DIGESTER 2 COVER REHABILITATION PROJECT

Contract Number: I100103-2721 / PWP No. WA-2019-112

Quotation Request No. 1

Title: Structural Steel Repairs

1 STEEL BEAM REPAIRS
SCALE: 3" = 1'-0"

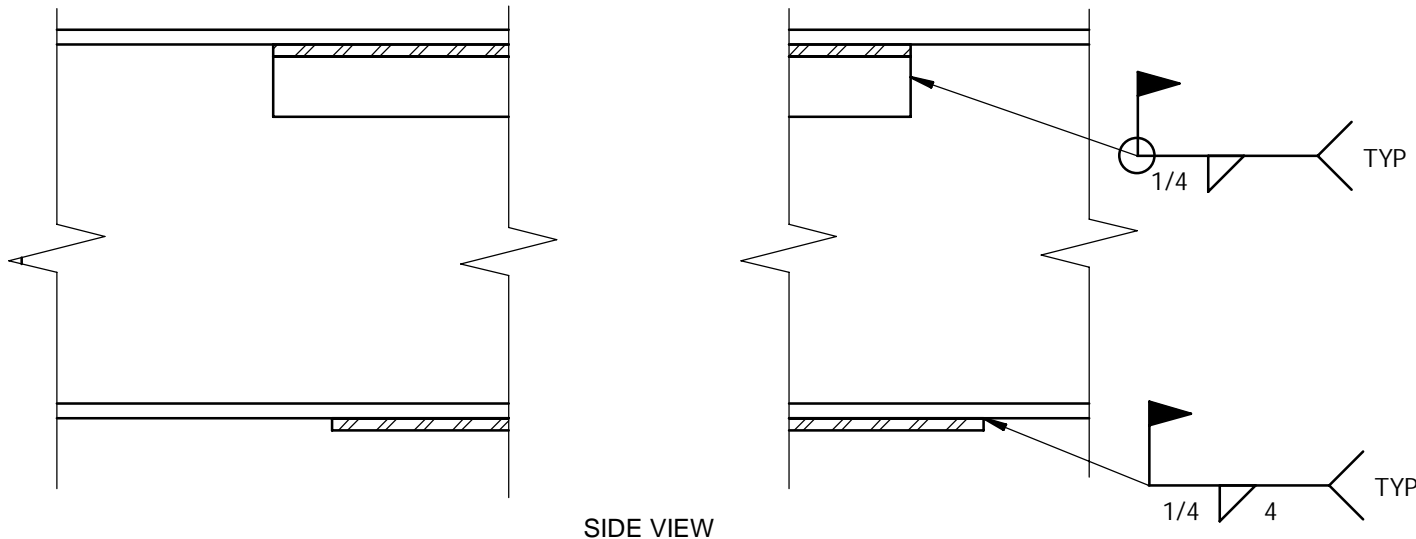
1. Replace all beam bolts with A307 bolts to match the existing bolts size and length throughout the Digester cover.
2. Perform Beam Repairs as marked in chalk in the field. Top chord repairs were marked on the beam web on the side to be repaired. Bottom flange repairs were marked on the bottom of the beam. Perform repairs as indicated in drawing SK-1.

- NOTES:
1. ALL WELDS E70XX ELECTRODES.
 2. ALL WELDING PER AWS.
 3. ALL BARS AND PLATES: ASTM A 36.
 4. BOTTOM FLANGE REPAIR PLATES: 1/4" X 4-3/4" MIN. DETERMINE LENGTH FROM FIELD MARKS ON BOTTOM OF BEAM.
 5. TOP FLANGE REPAIR: #6 ASTM A706 REBAR OR 1/4" X 3" PLATE SEE DETAIL. DETERMINE LENGTH FROM FIELD MARKS ON BEAM WEB.
 6. BEAMS ARE CURVED - BENT PLATE MAY REQUIRE CURVE FOR INSTALL.
 7. GRIND EDGES SQUARE VERTICALLY TO ACCOMMODATE FILLET WELD.
 8. TOP FLANGE WELD MAY REQUIRE PP FILLER WELD DUE TO THE TAPER OF THE CORROSION.
 9. AT THE END OF EACH REPAIR PLATE, WELD ENTIRE EDGE TO BEAM USING 1/4" FILLET WELD.
 10. ALL PLATES TO BE CONTINUOUS FULL LENGTH BETWEEN FIELD MARKS. SPLICES REQUIRE COMPLETE PENETRATION WELDS.

COLUMN REPLACEMENT

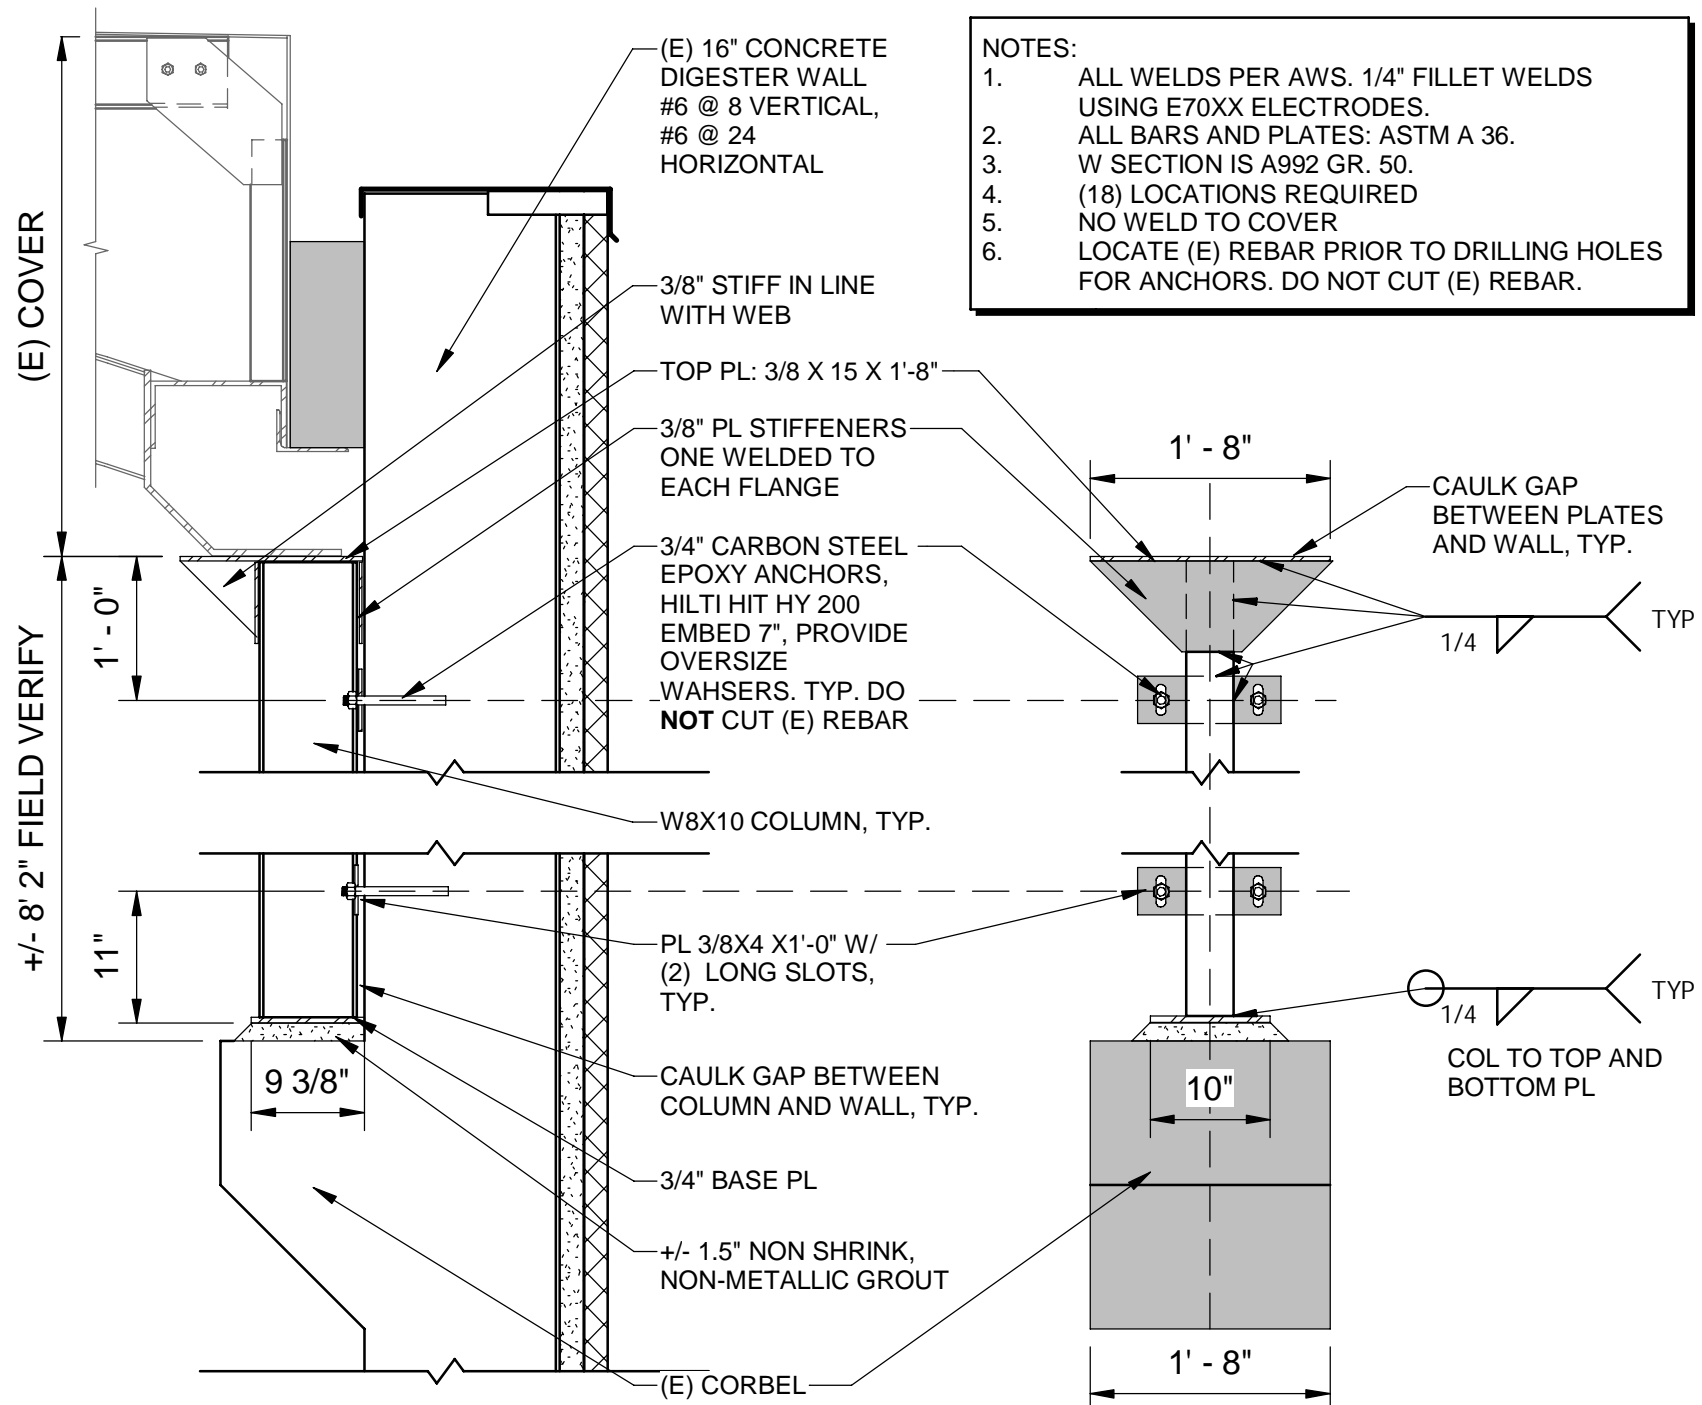
3. Install 18 new columns to match the existing columns. The new columns shall be installed on the existing empty corbels. A drawing of the existing columns, detail A in drawing 30-S-B, is included for reference from the structural engineer. Columns shall match the existing columns, except the existing corbels shall not be drilled into. Delete the anchors in the base of the column. Install grout between the column base and corbel. Scan the concrete wall to locate existing rebar prior to drilling into the existing concrete wall. Rebar shall not be cut to install concrete anchors. Each column has 6 horizontal concrete anchors.

1. ALL WELDS PER AWS. 1/4" FILLET WELDS USING E70XX ELECTRODES.
2. ALL BARS AND PLATES: ASTM A 36.
3. W SECTION IS A992 GR. 50.
4. (18) LOCATIONS REQUIRED
5. NO WELD TO COVER
6. LOCATE (E) REBAR PRIOR TO DRILLING HOLES FOR ANCHORS. DO NOT CUT (E) REBAR.
